2010 State Street Old Sixth Ward

## Revision to Approved HP2022 0028 (April 2022)

#### CERTIFICATE OF APPROPRIATENESS

August 14, 2025 HP2025\_0203 REVISION

## **EXISTING CONDITION**SOUTH ELEVATION

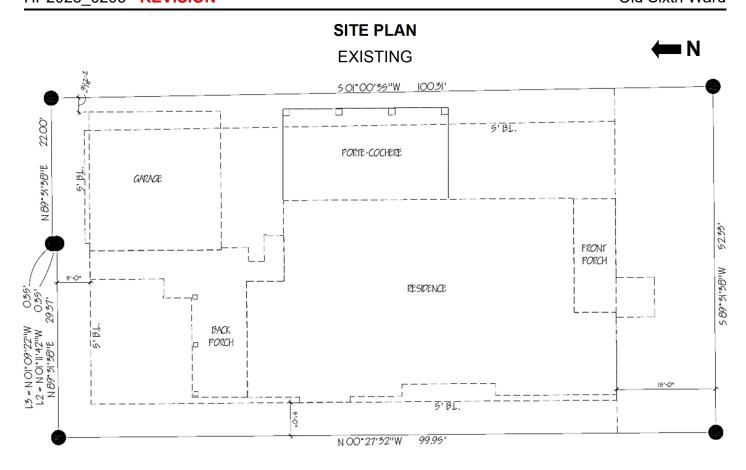
> 1) Remove existing flared foundation skirt of cementitious siding, exposing brick foundation piers around house.

- a. Extend smooth cementitious siding part way down between brick foundation piers, siding supported with 2" x 4" 's.
- b. Add lattice panels to span remainder of area below siding, to the ground, spanning between brick piers. To meet building code.
- 2) Replace existing wood and Trex front stairs with a brick staircase.

Brick piers have been exposed; flared skirting of siding has been removed.

Brick piers have been exposed; flared skirting of siding has been removed.
